Site Assessment

Hereford Point

Roman Road, Hereford HR4 9QP

Reviewed - 21-08-2024

5.4 Services – plumbing

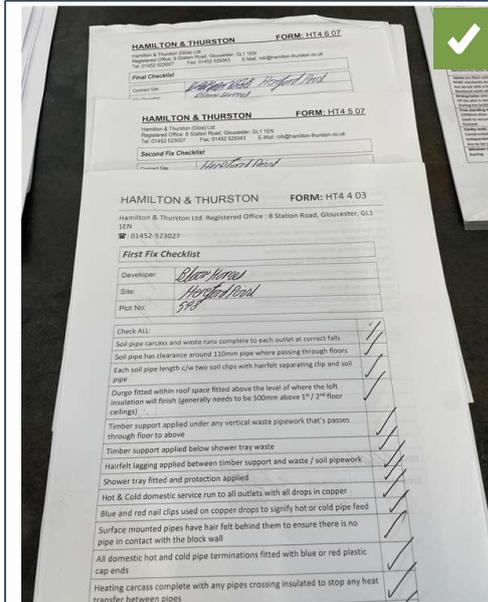
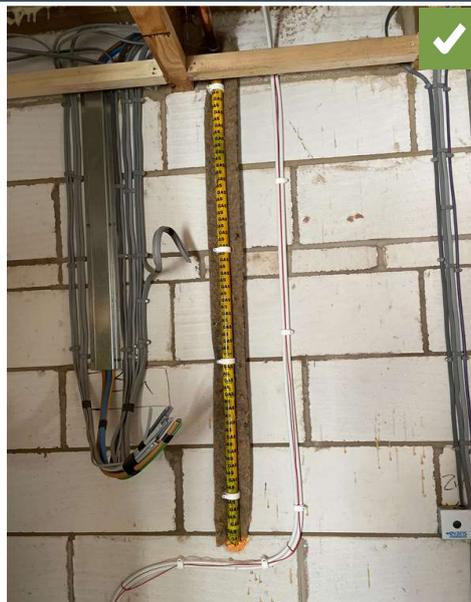
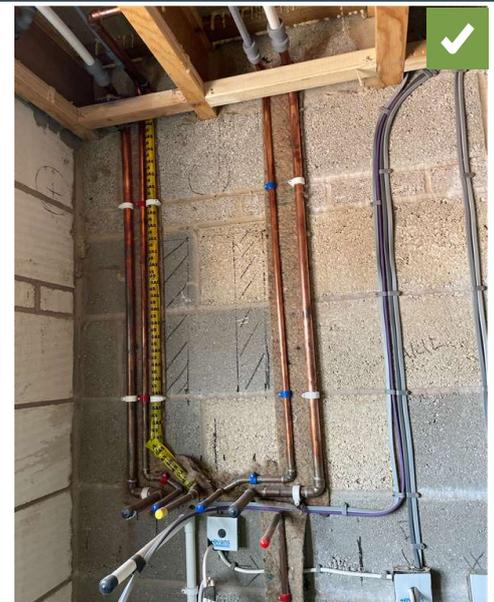
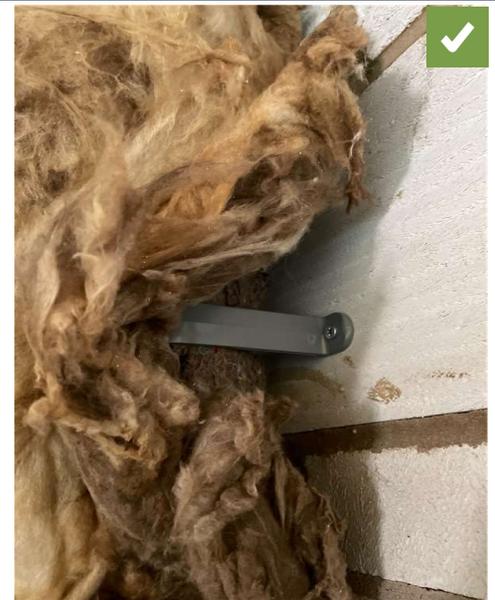
- 1 plot was available and viewed at this build stage, plot 545.
- Component/product/material details: Hot & cold-water supply & distribution / Gas supply / Protection.
- Contractor details: Hamilton & Thurston (Plumbing contractor).
- Quality was very good and consistent across the plot seen.

- Gas pipework was visibly identified.
- Hot and cold pipes were identified.
- Protection was provided to copper pipes installed on masonry walls.
- Tracer wire was provided to plastic pipework.
- Pipework was sleeved where passing through the joists.
- Pipework was well set out in straight runs.
- Pipework was neatly clipped, with support not exceeding 600mm centres.
- Soil vent pipe had the correct vertical fixing centres as per manufacturer's requirements.
- Waste pipes were installed in accordance with manufacturer's instructions.
- Air admittance valve was appropriately ventilating the soil vent pipe.

5.5 Services – ventilation

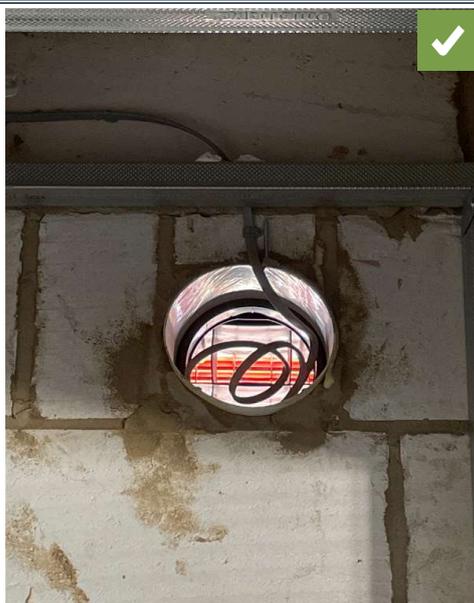
- 1 plot was available and viewed at this build stage, plot 545.
- Component/product/material details: Rigid ducting.
- Contractor details: Clarkson Evans (Electrical contractor).
- Quality was very good and consistent across the plot seen.

- Ducting penetrations at external walls were slightly sloped towards the outside.
- Insulated ducting was installed in unheated areas.
- Ducting was securely connected to the vent with a jubilee clip.
- Pattresses were provided for fixing of ceiling mounted fans.

5.6 Non-load bearing and compartment walls

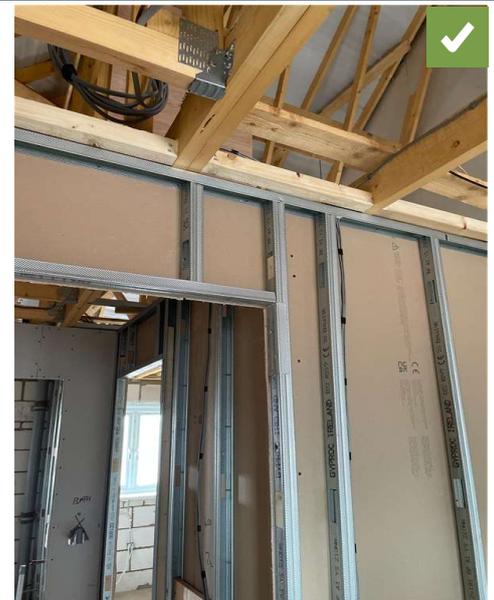
- 1 plot was available and viewed at this build stage, plot 545.
- Component/product/material details: Metal Stud Partition (BG - Gypframe).
- Contractor details: Johnson Drywall Ltd (Drylining contractor).
- Quality was very good and consistent across the plot seen.

- Studwork was constructed plumb and square.
- Additional noggings installed above stair string.
- The studwork was mechanically fixed to the structural frame.
- General studwork was installed at 400mm centres.
- Additional studs were installed above door heads to enable plasterboard staggering.
- Additional timber added to base rail for added strengthening.
- Metal stud had been correctly lapped and fixed at corners of door openings.
- Timber was provided at door openings to aide with strengthening as per manufacturers details.

6.1 Services - electrical including equipment

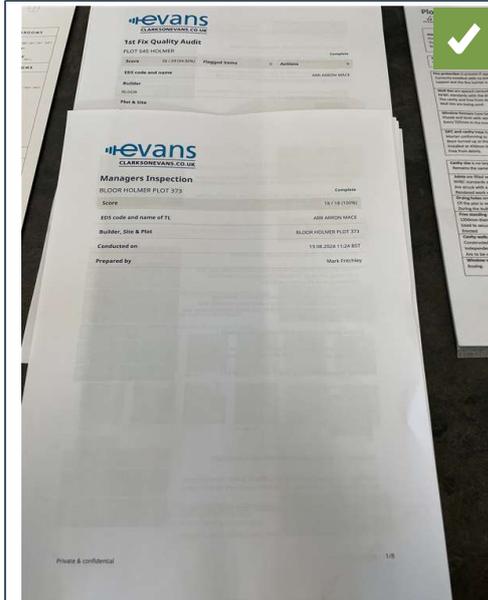
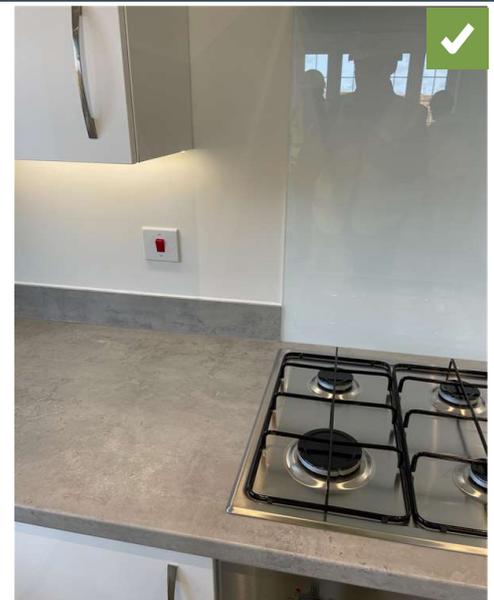
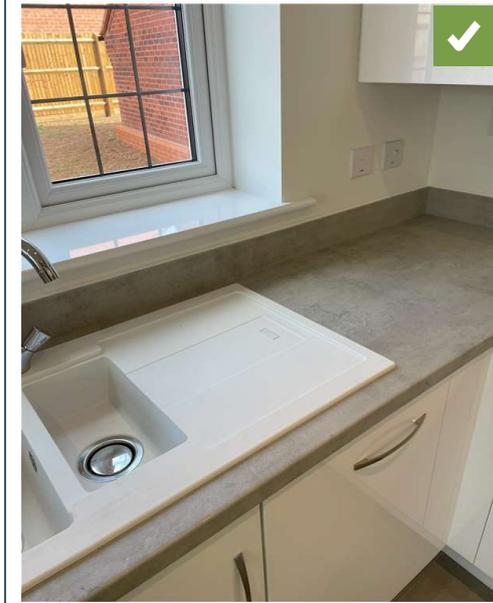
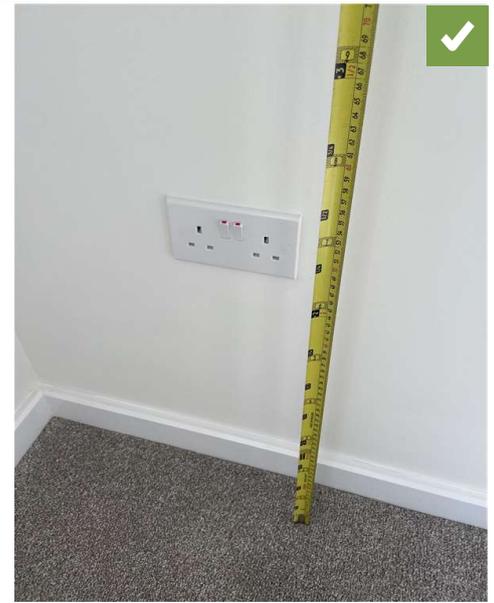
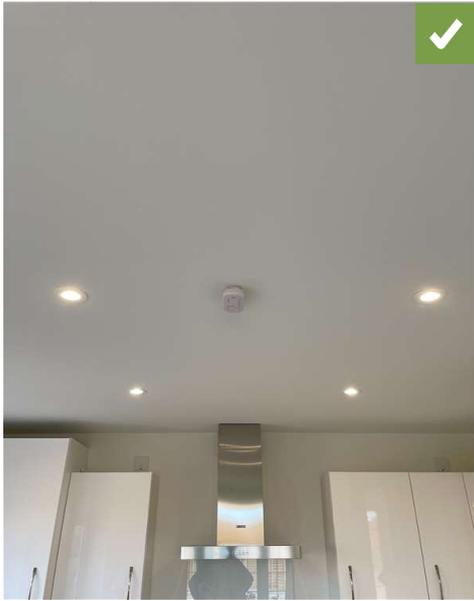
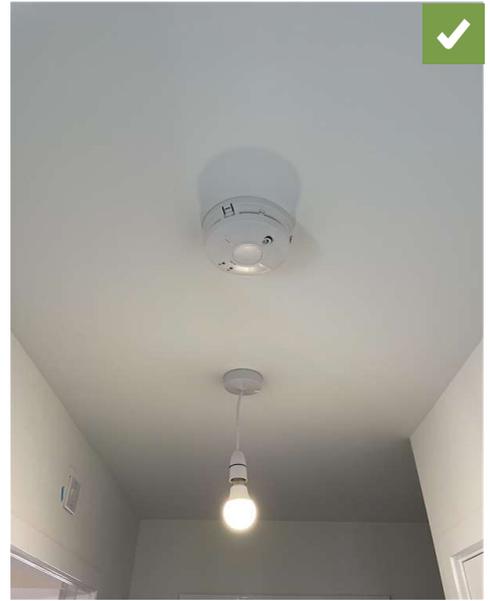
- 1 plot was available and viewed at this build stage, plot 370.
- Component/product/material details: Electrical outlets / Lighting / Consumer Unit / Detection & alarm systems.
- Contractor details: Clarkson Evans (Electrical contractor).
- Quality was very good and consistent across the plot seen.

- Quality control documentation was completed and viewed.
- Electrical accessories were positioned a minimum of 100mm away from hobs.
- Electrical accessories were positioned a minimum of 300mm away from basins and sink bowls.
- Switches, sockets and face plates were aligned with equal margins.
- Sockets and switches were positioned at a height between 450mm - 1200mm to the centre line.
- Consumer unit circuits were clearly labelled.
- Additional surge protection applied to circuits within consumer unit.
- Consumer unit positioned with switches between 1350mm - 1450mm above floor level.
- A good level of symmetry was evident to ceiling fittings.
- The alignment of electrical accessories was very good.

6.2 Services - plumbing including equipment

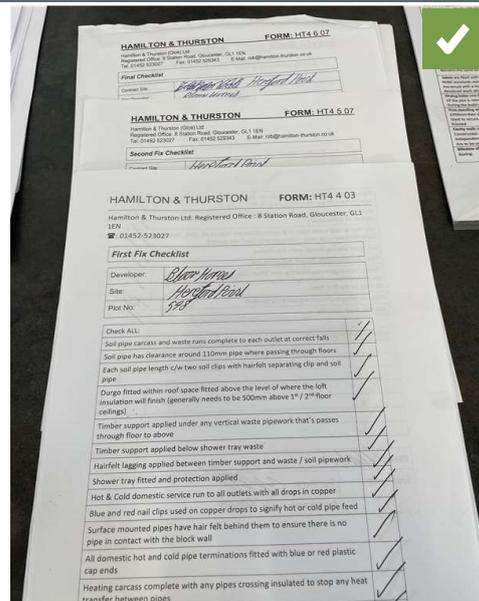
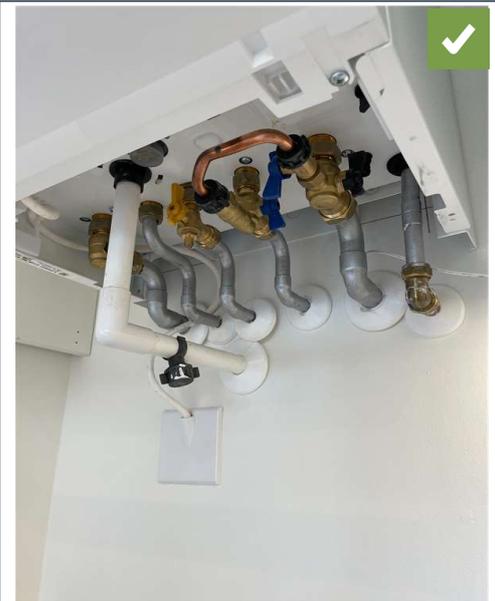
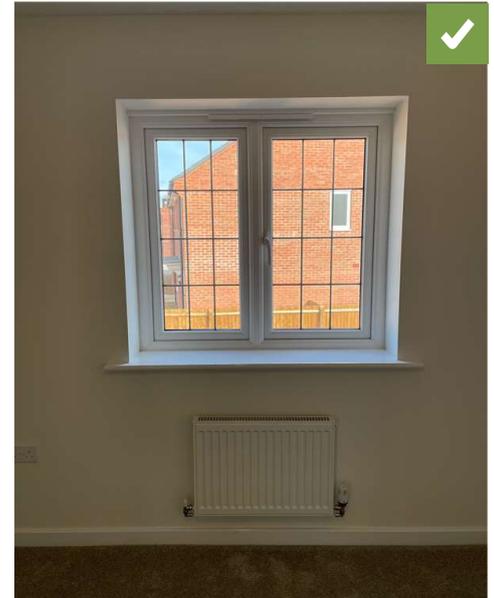
- 1 plot was available and viewed at this build stage, plot 370.
- Component/product/material details: Space heating system / Combination Boiler (Ideal Logic) / Radiators / Sanitary ware.
- Contractor details: Hamilton & Thurston (Plumbing contractor).
- Quality was very good and consistent across the plot seen.

- Quality control documentation was completed and viewed.
- Flue joints were accessible for inspection.
- Boiler pipework had been installed neatly.
- Compression joint for safety valve drain fitted to aid pipe removal during boiler servicing.
- Accessible WC was installed in compliance with Approved Document Part M.
- Sanitaryware was securely installed and neatly aligned.
- Kitchen sink installed parallel to the edge of the worktop.
- Kitchen sink pipework was neatly installed.
- A proprietary isolation valve was installed as per the specifications.
- Shower hose restricted with restraining ring/clip to prevent back flow.
- Radiators were installed within the centre line of the window.

6.3 Joinery

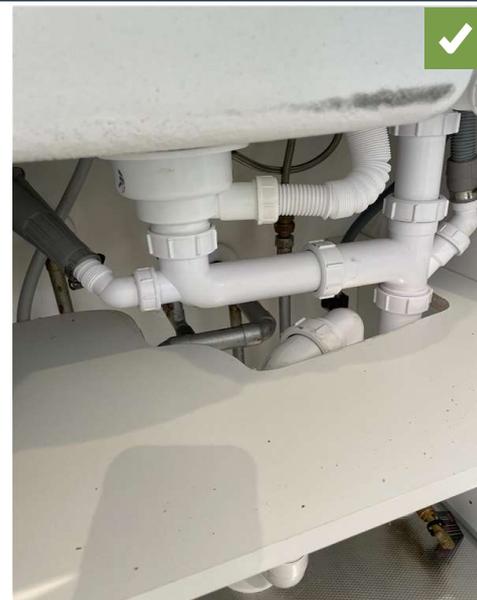
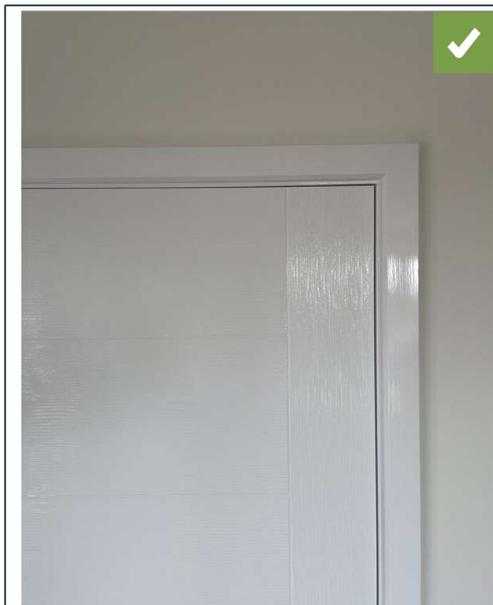
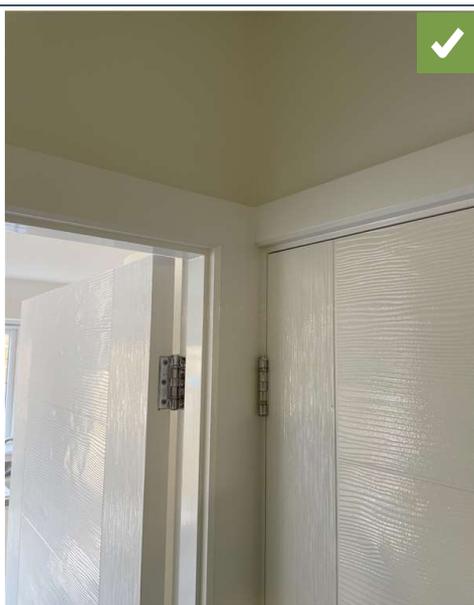
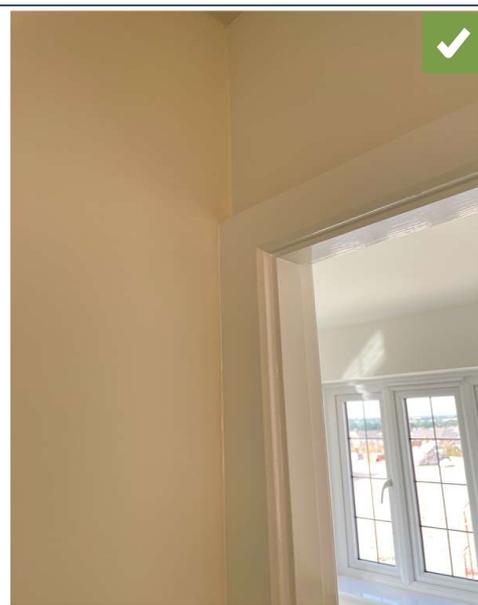
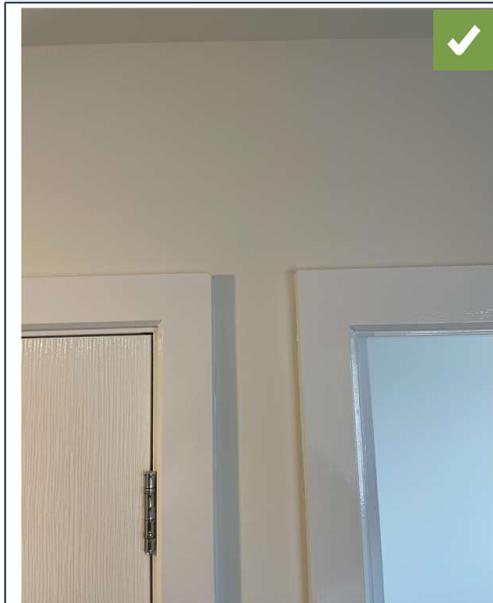
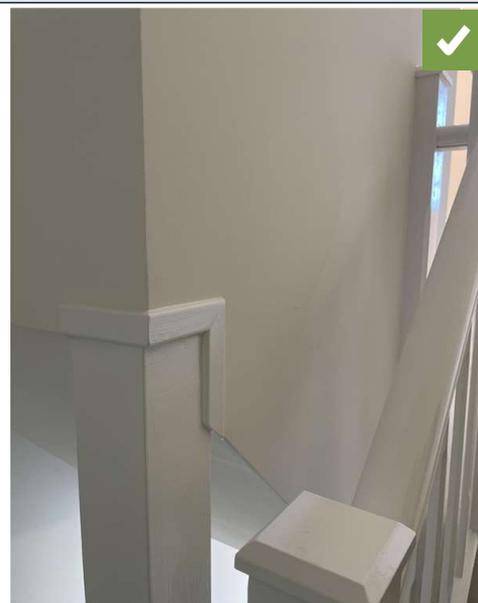
- 1 plot was available and viewed at this build stage, plot 370.
- Component/product/material details: Kitchen (Symphony) / Internal doors & ironmongery / Skirtings / Architraves / Handrails.
- Contractor details: Lewis Carpentry Contractors (Carpentry contractor) / Symphony (Kitchen fitters).
- Quality was outstanding and consistent across the plot seen.

- Kitchen units had been installed securely with a consistent line and level.
- Kitchen worktop mitres were cut with precision, fitting tightly and flush.

7.1 Internal finishes

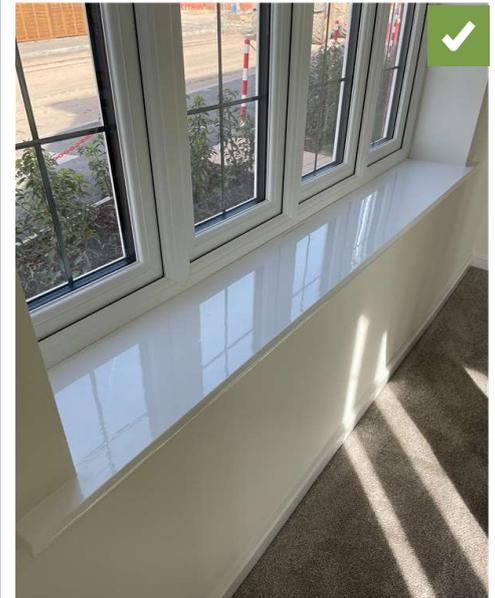
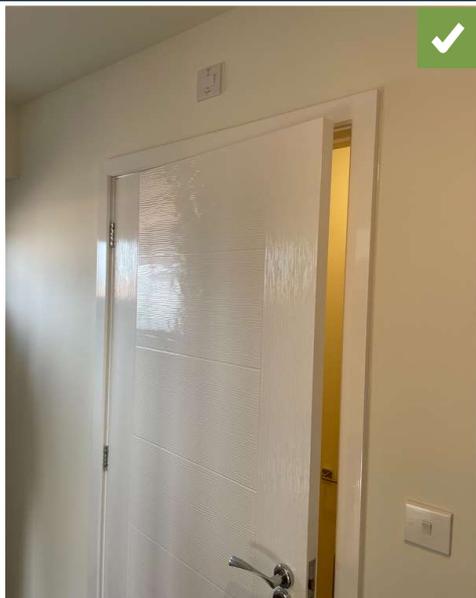
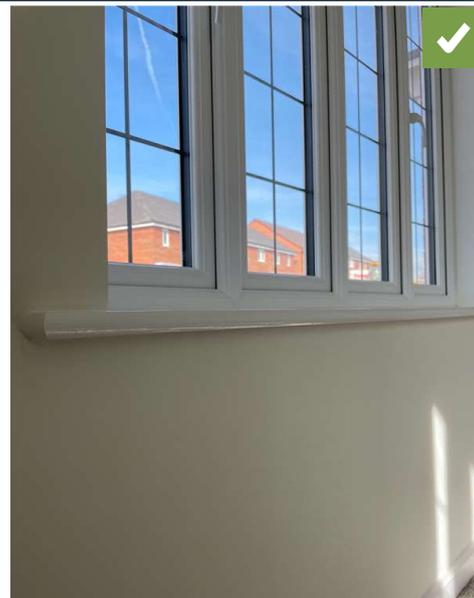
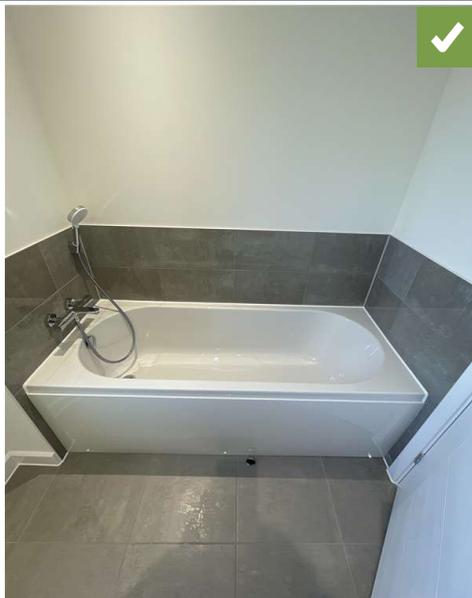
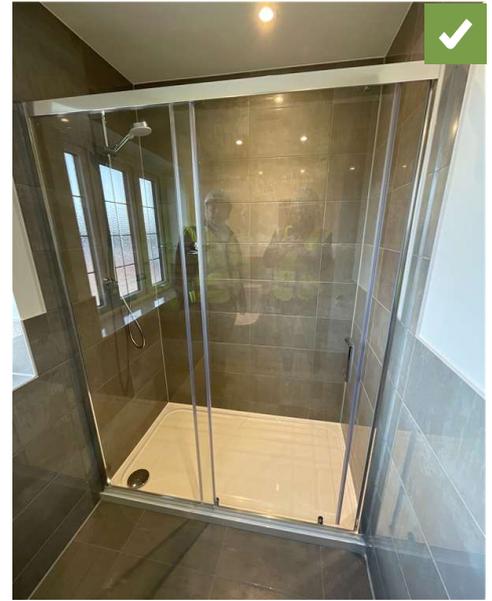
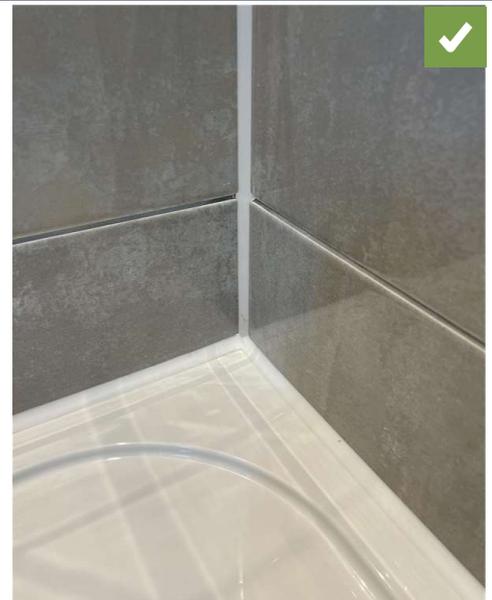
- 1 plot was available and viewed at this build stage, plot 370.
- Component/product/material details: Internal decorations / Wall tiling / Internal mastic.
- Contractor details: Pace Decorating (Decorators) / Future Mastic (Mastic applicators) / Richard Marshall (Floor & wall tiling contractor).
- Quality was outstanding and consistent across the plot seen.

- Clean and crisp lines were maintained at wall/ceiling junctions.
- Decorative finish to walls and ceilings had a consistent and even appearance.
- Finishes were free from conspicuous runs or prominent brush marks.
- The paintwork was of a high quality finish.
- High-quality decoration was below window boards.
- The tops of doors and architraves were glossed.
- Ceramic tiling was level with flush junctions between tiles.
- Grouting was a uniform colour and free from blemishes.
- Setting out of tiling was consistent across areas seen.
- Ceramic tiling continued past the end showers and baths to achieve a better aesthetic finish.
- Tile trims were neatly jointed and flush to tile edges.
- Mastic seals were colour-matched.

7.2 Floor finishes

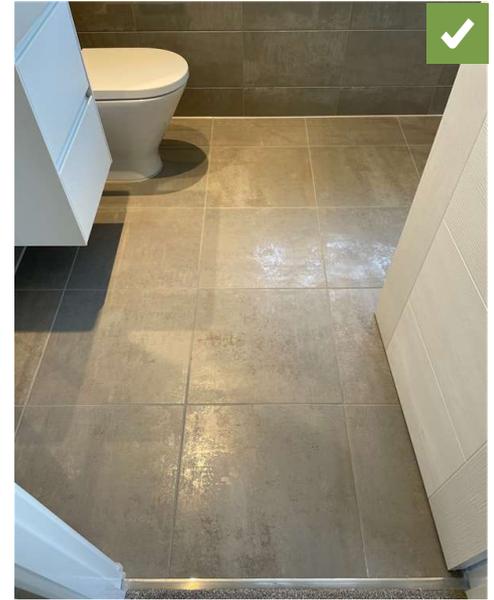
- 1 plot was available and viewed at this build stage, plot 370.
- Component/product/material details: Vinyl flooring / Preparation / Application / Protection / Mastic.
- Contractor details: DCF Flooring (Flooring contractors) / Future Mastic (Mastic applicators)
- Quality was very good and consistent across the plot seen.

- Floor tiling was level with flush edges between tiles.
- Floor tiling was set out to minimise unsightly cuts at the edges.
- Grouting was a uniform colour and free from blemishes.

7.3 External finishes

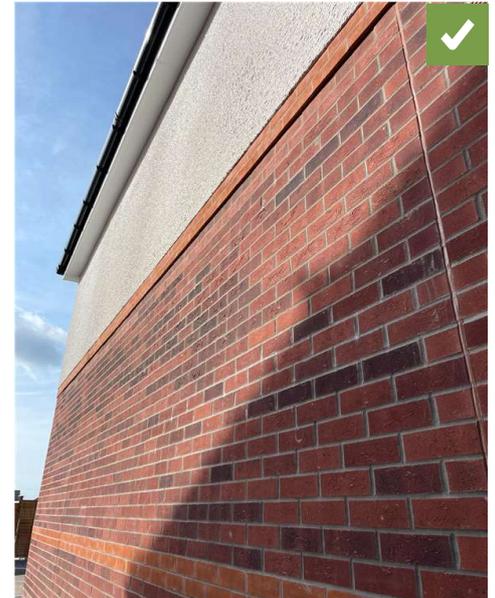
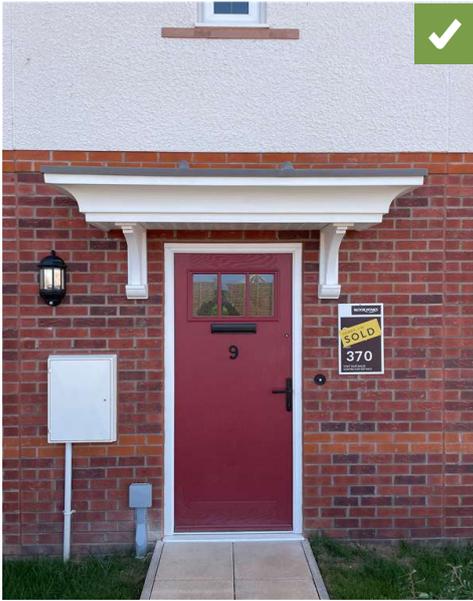
- Multiple plots were available with 7 viewed at this build stage, plots 364, 365, 366-367, 368-369 & 370
- Component/product/material details: External finishes & details.
- Contractor details: Pace Decorating (Decorators).
- Contractor details: Future Mastic (Mastic applicators).
- Contractor details: Malvern Brickwork (Bricklaying contractor).
- Contractor details: Clarkson Evans (Electrical contractor).
- Contractor details: Hamilton & Thurston (Plumbing contractor).
- Quality was very good and consistent across the plot seen.

- Facades and surfaces were clean with a good visual appearance.
- GRP canopies were installed in accordance with BBA certificate/manufacturers guidance.
- Mastic seals were neatly applied with a uniform size of bead.
- Boiler flue correctly sealed with the gasket/proprietary cover fitted tight to external finish.
- Service ducts were installed plumb.
- Service ducts were secured using clips.
